DEVIATION REQUEST

Eagle Rising Project Name:

Eagle Rising 2022 Update (LSC #S224260)

Roadway Classifications and Roadway Surface

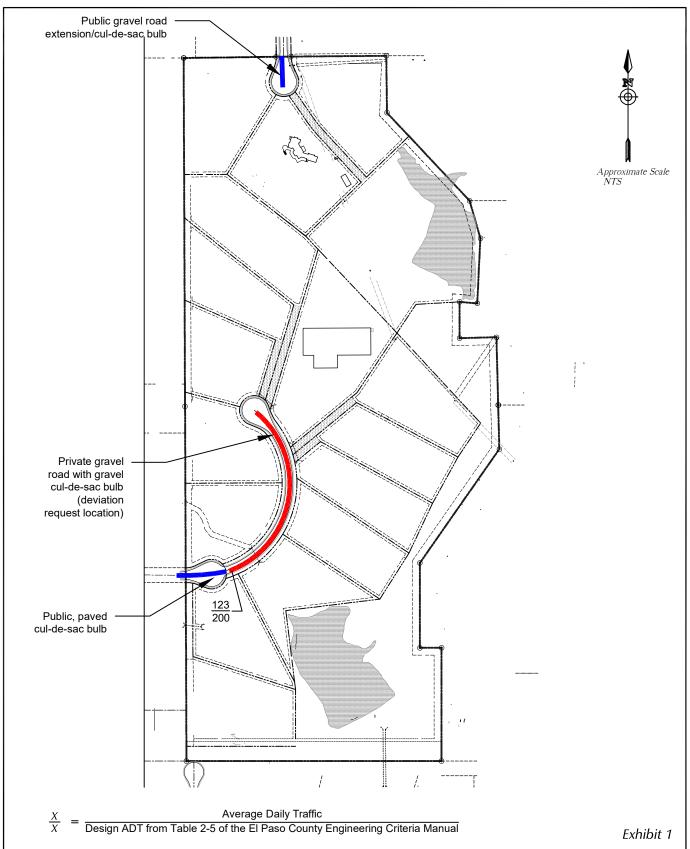
A paved apron extending 50 feet from the end of the public cul-de-sac will be required to minimize tracking of gravel road materials into the cul-de-sac; state that this will be provided (or it can be added as a condition of approval)
